NEW
RIVER

Burgess Hill

Design & Access Addendum

Proposed Section 73 Amendments

3.4 Food Store Adjustments

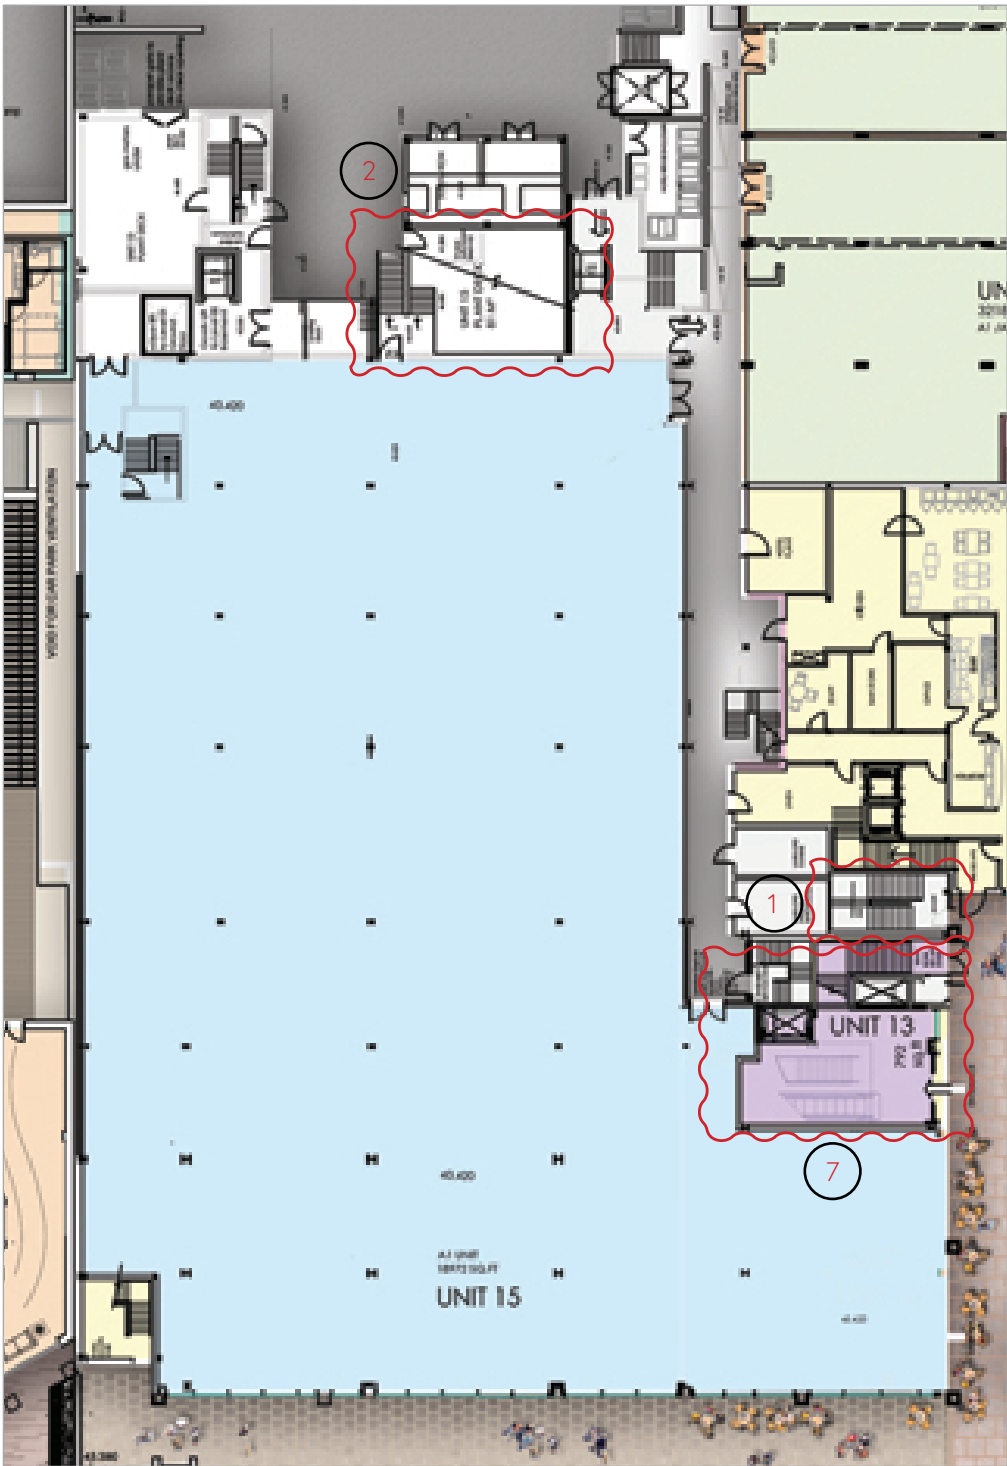
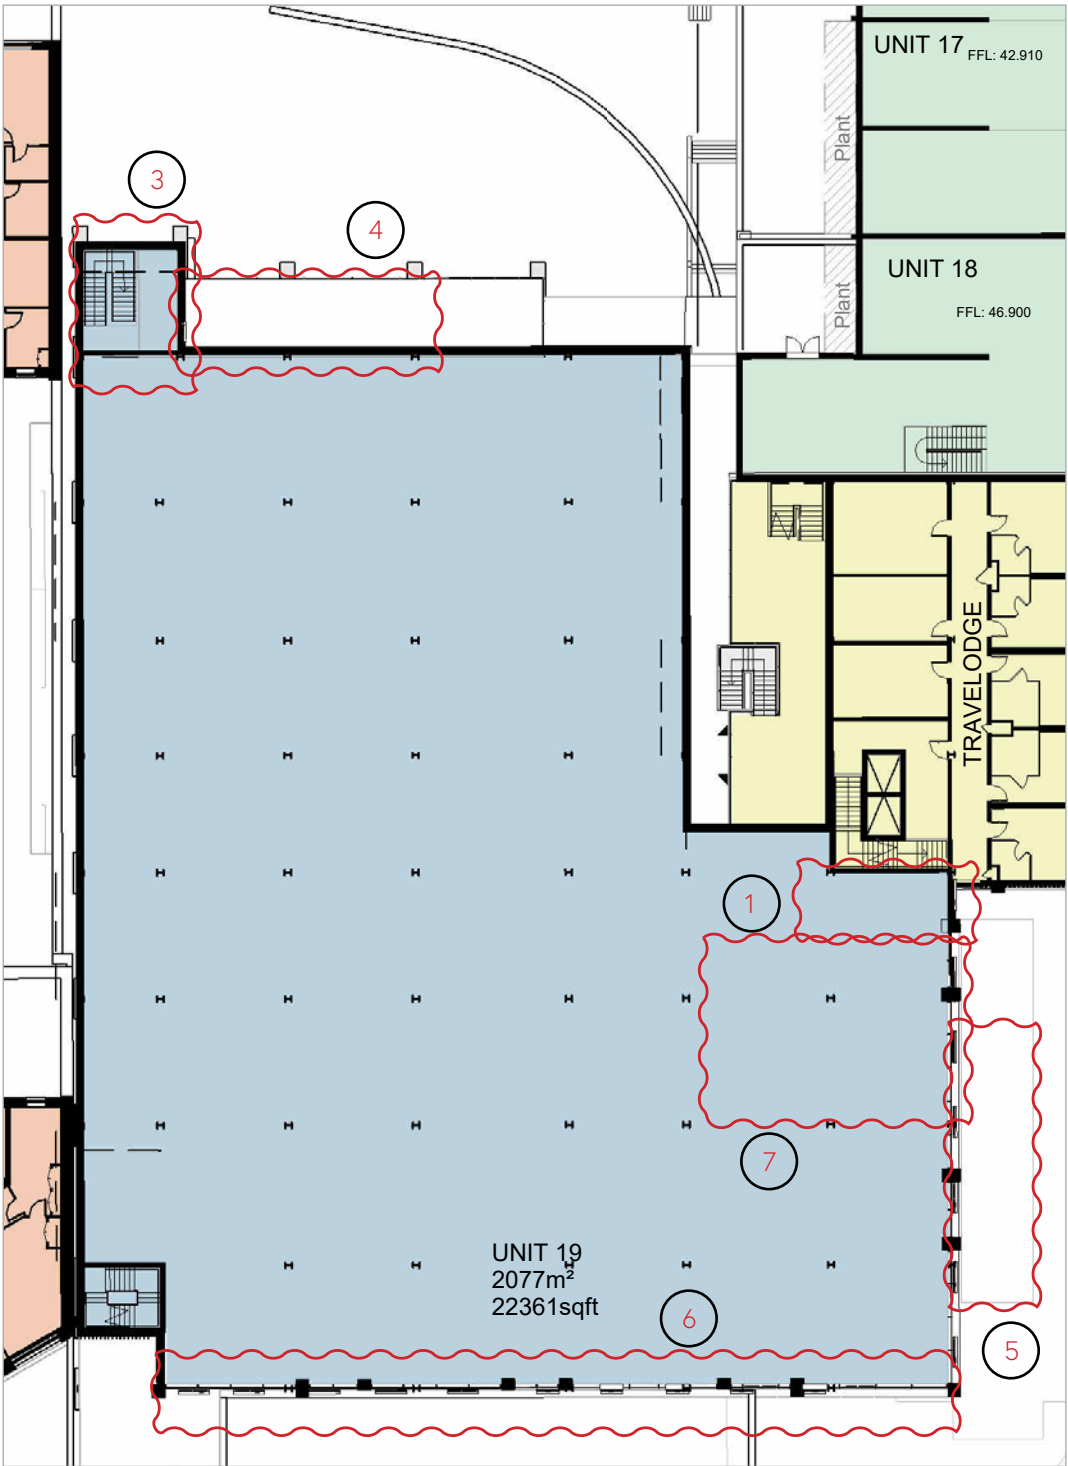
- 1. Isolated maintenance stair (and associated riser room) which provided separate access to the roof level of Block A2 for maintenance of the Telecom Mast has been omitted, footprint of the stairwell at Ground Floor Level is absorbed within the Food store increasing the overall store size.

- 2. Plant Space for the Food Store relocated from the service yard to the plant deck at Level 02.
- 3. Access to the Plant deck will now be provided via a dedicated stair core which is located where the Bowling Alley Plant area is no longer required.

- 4. Loading Bay re-designed to tenant requirements which includes a security curtain and a single pair of double doors for fire escape from the retail space.

- 5. External trolley park with canopy structure proposed adjacent to the food store entrance in line with Tenant requirements.
- 6. Elevational adjustments to align columns at ground floor with the bays of the hotel above.

- 7. Omission of the entrance lobby and stair for Unit 13/Bowling Alley. Footprint at Ground Floor Level is absorbed in the food store footprint.

3.5 Hotel Adjustments

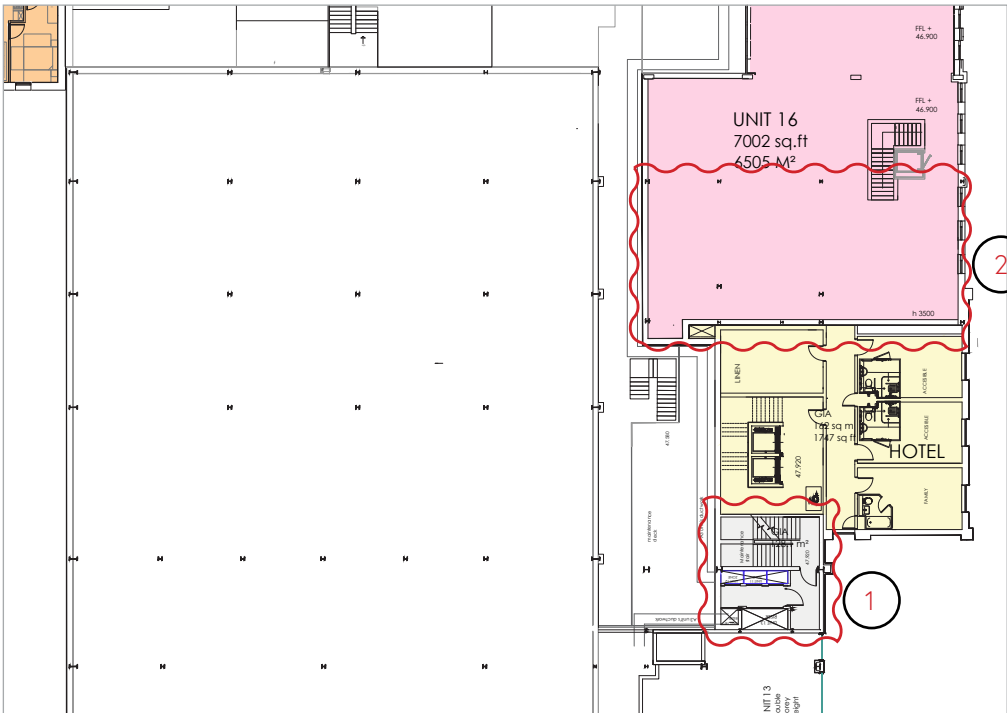
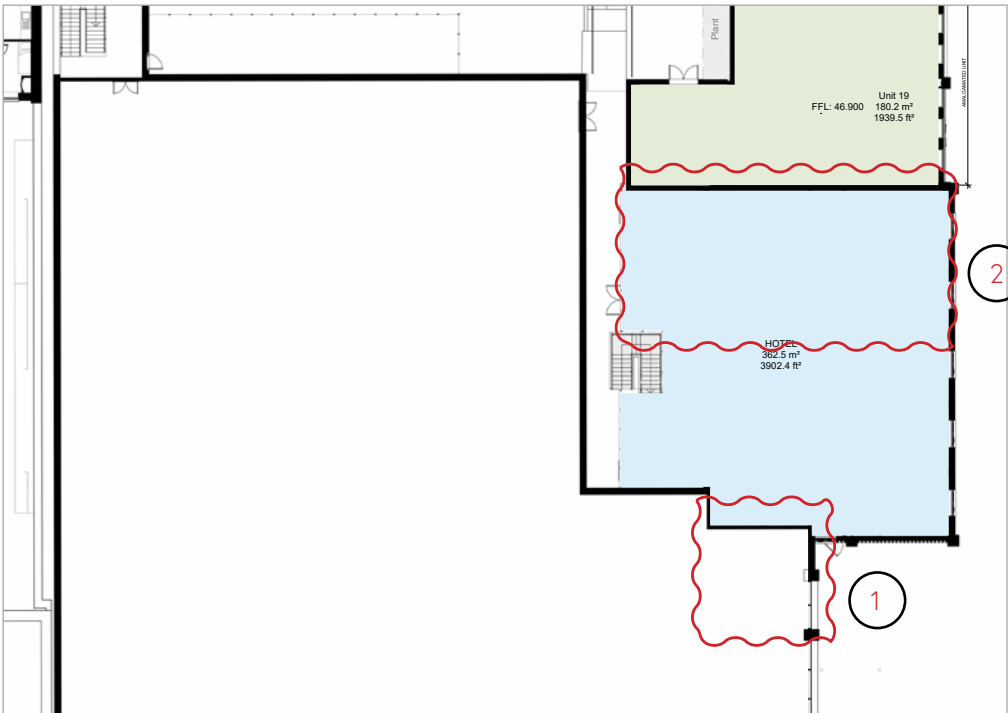
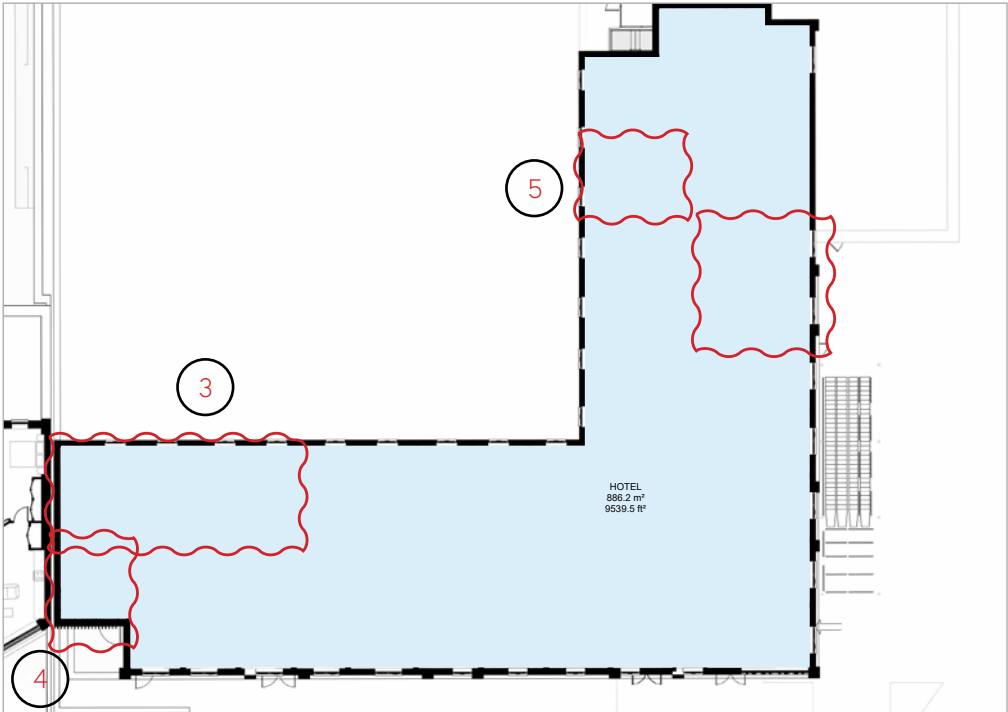
- 1. Isolated maintenance stair (and associated riser room) which provided separate access to the roof level of Block A2 for maintenance of the Telecom Mast has been omitted. At Levels 03/04/05 this space is attributed to the hotel enabling two additional rooms (1 Family & 1 Double) on each floor. Total plus 6 additional rooms.

- 2. At Level 02 the hotel demise has been extended into the retail space (previously Unit 12). This enables the hotel demise to stack with the ground floor footprint rather than overlapping tenants. The additional footprint at Level 02 has been allocated as 2 additional Family rooms and Plant/Staff rooms as per the tenants Back of House requirements. Total plus 2 additional rooms.

- 3. Plant deck on the north facing rear elevation at Level 05 has been relocated to the flat roof of Level 02 with direct access via the plant deck from the service yard. The area of the building is infilled to stack with Level 04 which provides 4 additional double rooms. Total plus 4 additional rooms.

- 4. Secondary escape from the roof level is provided via an access hatch into the stair core on the boundary with Block A1.
- 5. Following design development of the M&E strategy the Internal Plant Room on the west facing rear elevation of Level 05 has been confirmed as not required. The revised scheme reassigns this area as an additional double room. Total plus 1 additional room.

- 6. Total Number of Hotel rooms has increased from 89 rooms to 102 rooms.

3.6 Hotel Adjustments

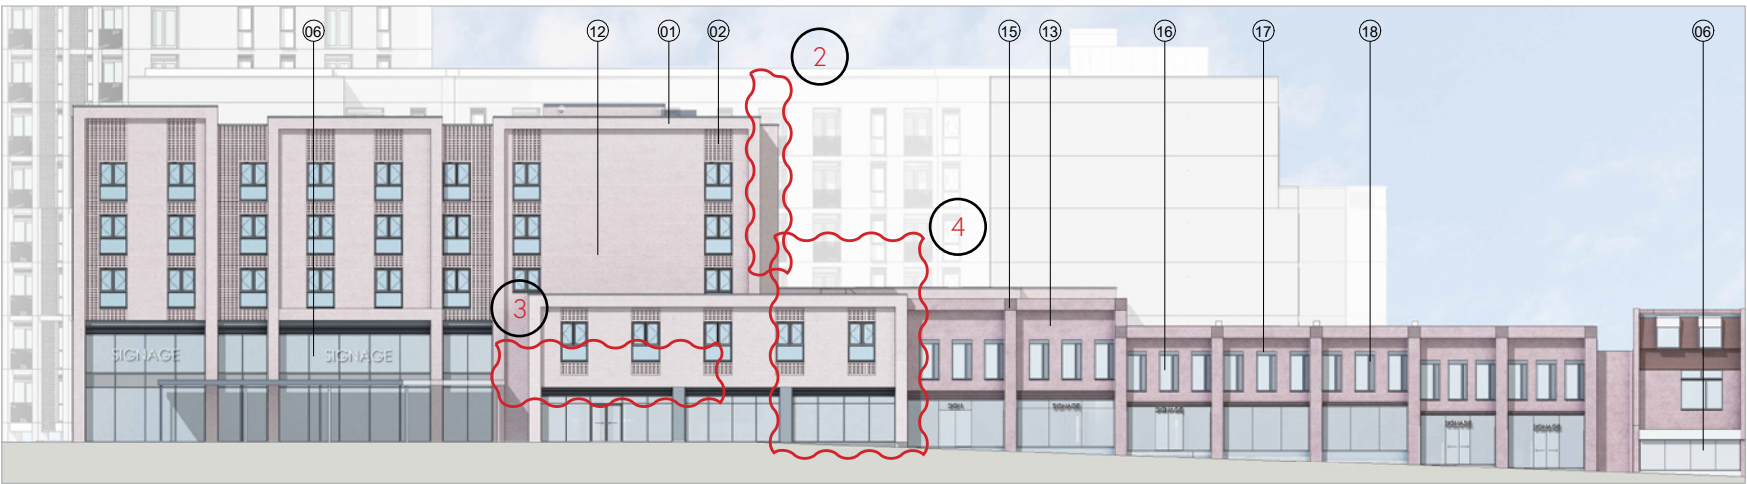
1. Façade bays adjusted to suit internal room widths in accordance with tenants standard room sizes.
2. Risers for Telecoms Mast relocated to the North facing elevation following the omission of the separate maintenance stair. Hotel tenant has confirmed roof access via the hotel stair is permitted.
3. Hotel Entrance Canopy omitted. Following user input, the hotel operator requested the omission of the canopy over the hotel entrance as it promotes unwanted congregation and smoking at the entrance of the hotel.
4. Extension of the first floor demise facing the existing Library to stack with the ground floor footprint.

3.7 Retail Units Church Walk

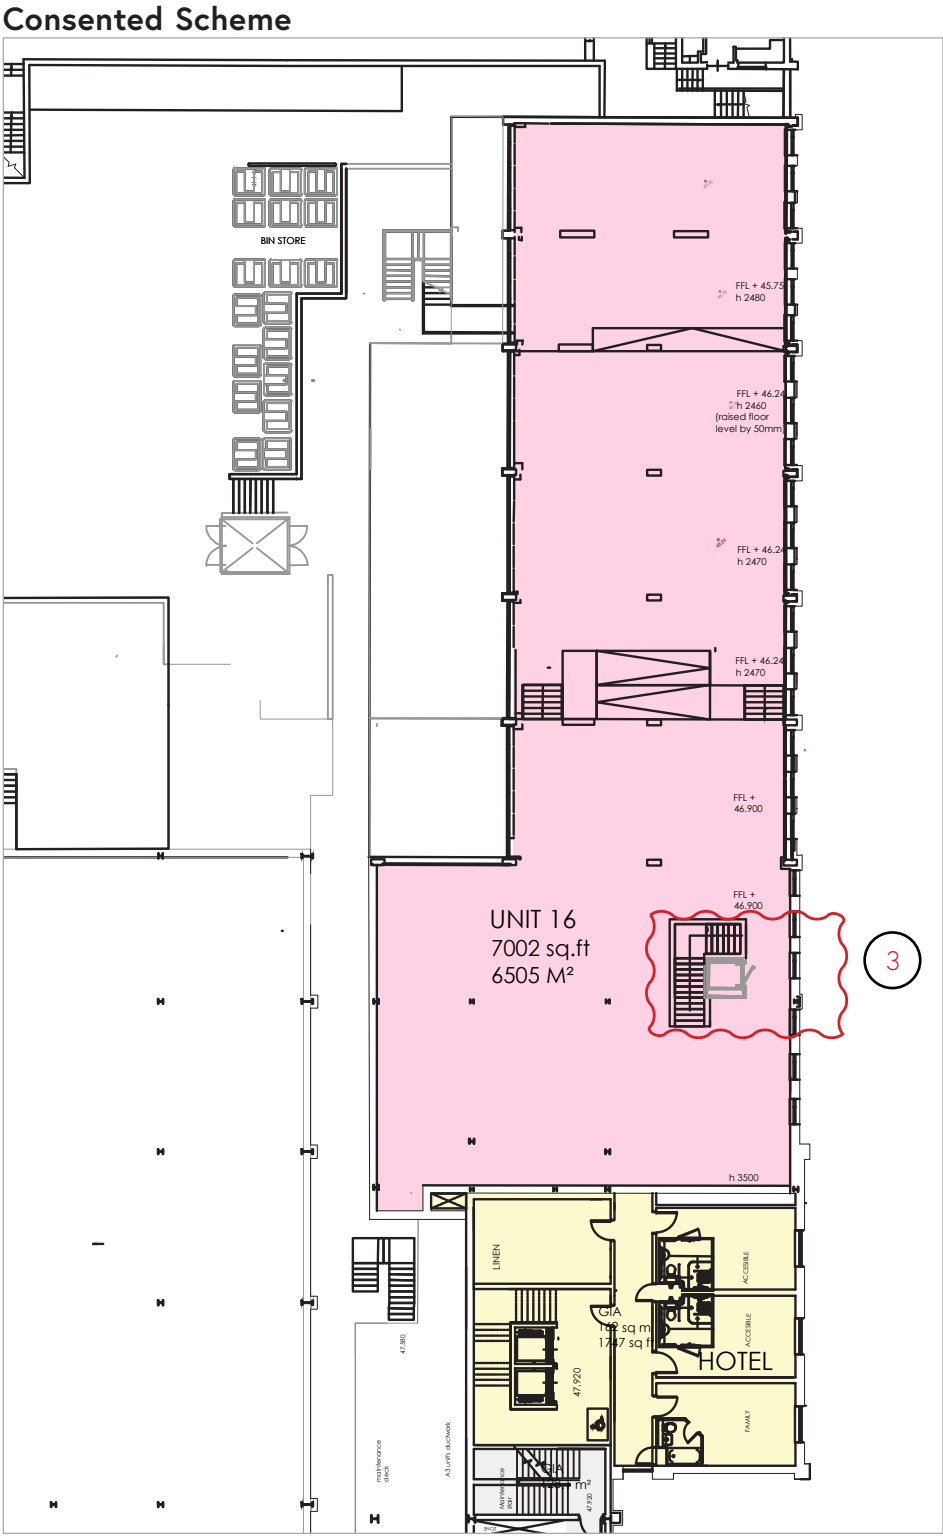
- 1. In the consented scheme retail Unit 8 amalgamated the existing units on Church Walk for use as a Gym. In this revised proposal the gym is relocated to the central Leisure Block facility (Block B) and the retail units are retained in their existing form as a series of small retail units on the high street of Church Walk.

- 2. Internally the adjustments that were previously consented to allow gym to occupy this space, including opening up of separating walls and ramping between varying floor levels, are no longer required. Instead the existing retail units will be stripped back, shell and core fit out completed and leased to tenants for full Cat B fit out.

- 3. The proposed new shop front at ground floor level will remain relatively unchanged to the consented application. However, with the above proposed strategy for separate retail units, each bay requires sliding entrance doors, whereas the consented application had fixed glazing to the central bays.

3.8 Retail Units - The Lanes

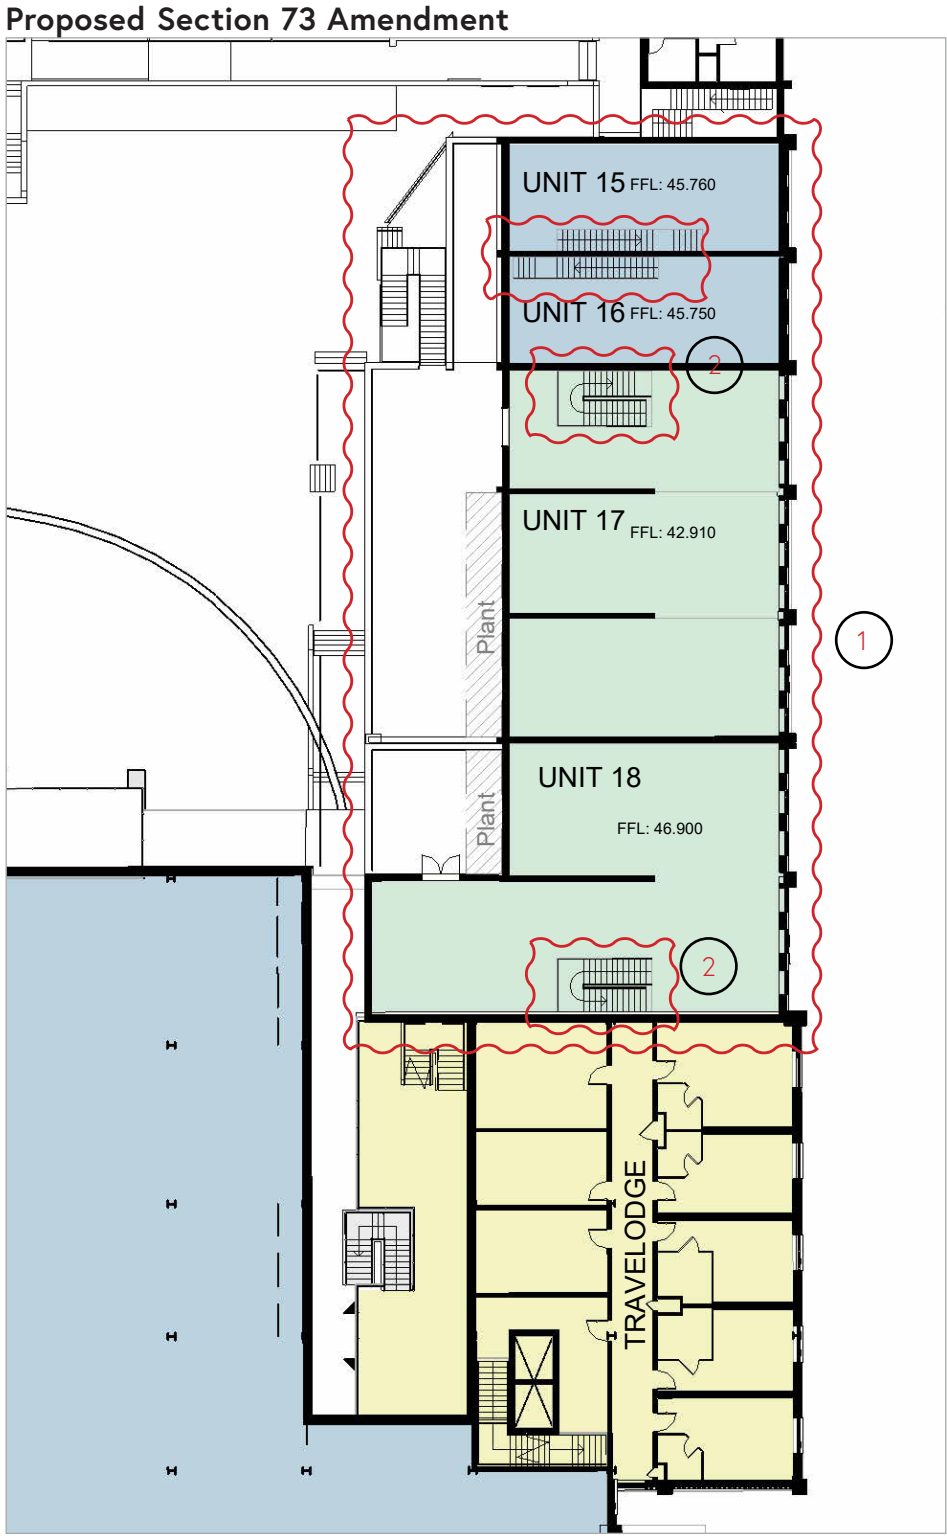
- 1. The consented scheme included an Office space - Unit 16 which was located at first floor level on Church Walk over the retail units 9/10/11/12. The consented office was open plan which required the existing buildings to be amalgamated by way of extensive structural work. The office spanned over varying existing floor levels which required ramped and stair connections. In the revised proposal the first floor office space is omitted. The existing first floor spaces are combined with the retail spaces below to provide 2 storey units for Units 15, 16, 17 and 18.
- 2. To facilitate the 2 storey retail spaces new staircases will be provided to each unit to give suitable public access to the first floor level.
- 3. The dedicated entrance to Unit 16, between the Hotel and Unit 12, will now be omitted and absorbed into the retail unit which is now labelled as Unit 18.
